# Duquesne Light Company

**Subject: Beaver Valley Power Station, Unit No. 1  
Docket No. 50-334, License No. DPR-66  
Response to Second Request for Additional Information  
Concerning Reactor Vessel PTS Assessment**

ATTACHMENT  
Beaver Valley Power Station, Unit No. 1  
Reactor Vessel PTS Assessment Second RAI Response

Figure 1  
Schematic Showing Relative Locations of Baffle-Barrel Formers  
Material Specimen Stackups and Dosimetry Locations  
Beaver Valley Unit 1

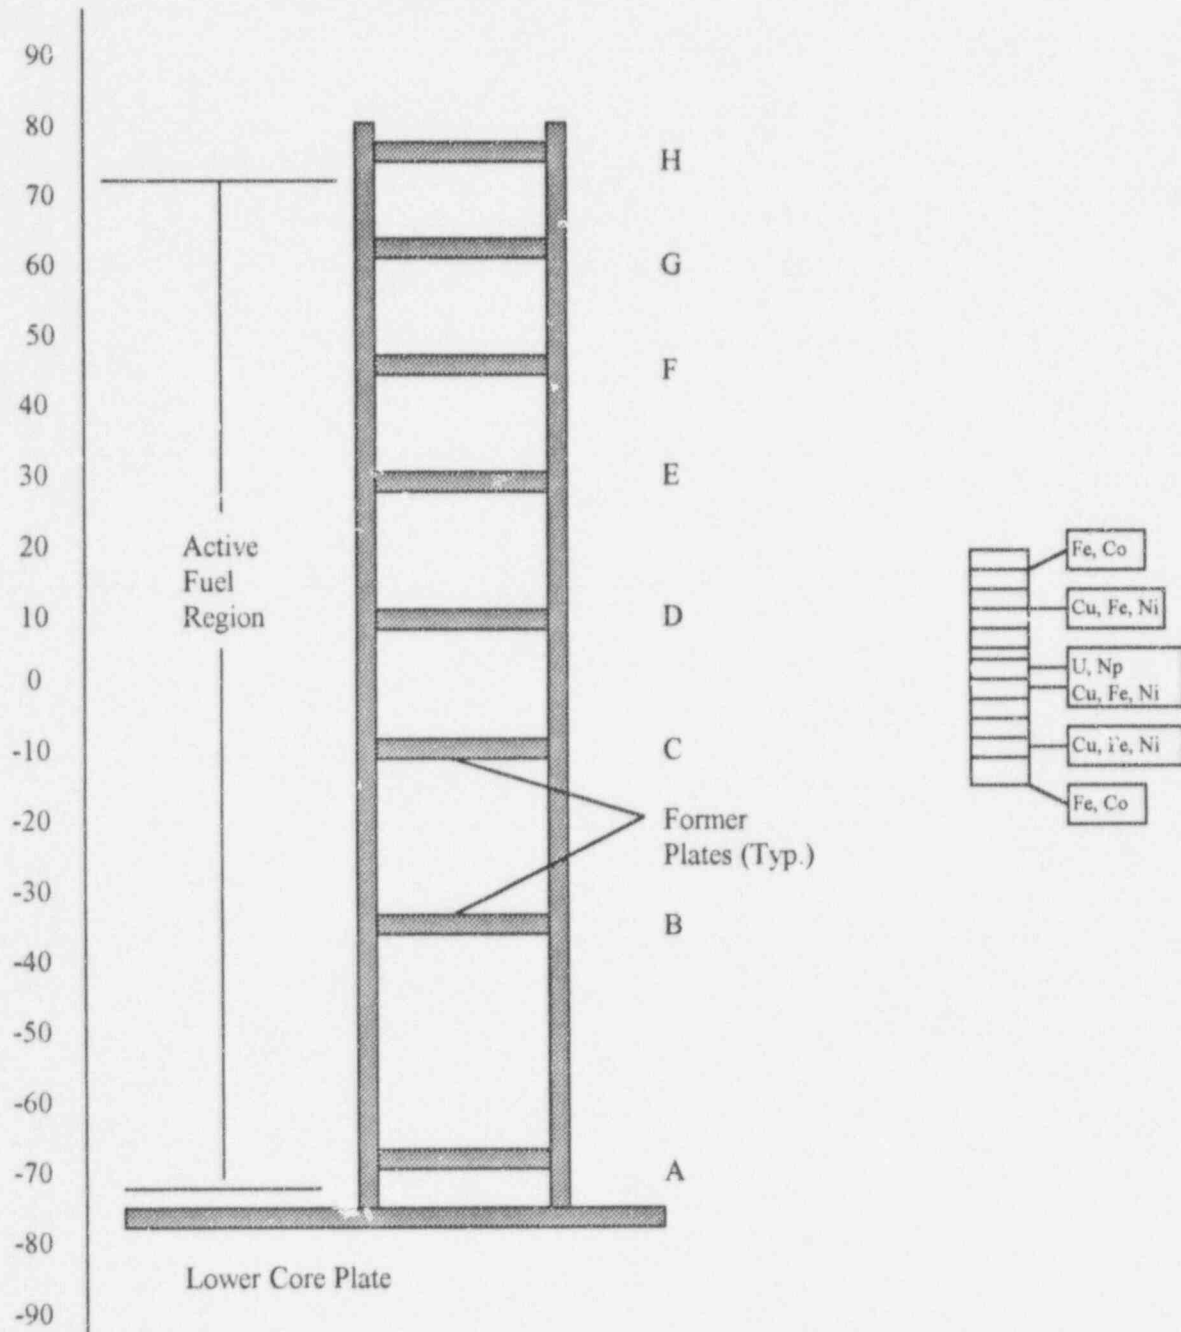
Recently, information provided from a French source has indicated that core barrel support rings may be shadowing surveillance capsules and the dosimeters within them, in some RPV surveillance programs. The NRC staff has begun to discuss this issue with Westinghouse. Westinghouse staff members are aware of the NRC staff's concerns that, if these supports are not modeled correctly, this may lead to deviations between measured and calculated neutron fluence values. Assess whether such a problem may exist for the measured and calculated fluence values in the case of BVPS-1 and provide drawings of the reactor vessel internals which show the relative location of the baffle radial support plates (baffle formers), the surveillance specimen capsules, and the dosimeters and Charpy impact specimens within the surveillance capsules.

The design of the Beaver Valley Unit 1 Reactor Vessel internals includes eight former plates spanning the radial distance between the external boundary of the baffle plates and the inner radius of the core barrel. Due to the shape of the perimeter of the reactor core, the radial extent of the former plates varies significantly with azimuthal angle. Therefore, an accurate evaluation of the effect of the presence of these former plates on the neutron environment at surveillance capsule and reactor vessel locations would require three-dimensional transport analysis.

The configuration of the former plates at Beaver Valley Unit 1 is depicted schematically in Figure 1 (attached). Also shown in Figure 1 are the relative locations of materials test specimens and dosimetry sensors within a surveillance capsule with respect to the former plates. From Figure 1, it can be seen that the surveillance capsules are impacted primarily by only former plates C and D. An expanded representation of the materials test specimens and dosimetry sensors relative to these two former plates is provided in Figure 2 (attached). The specific axial dimensions for the former plate elevations, the material test locations, and the dosimetry sensor elevations are listed in Tables 1 through 3, respectively. Relative to Figures 1 and 2, as well as Tables 1 through 3, it should be noted that all dimensions are referenced to the axial midplane of the active core.
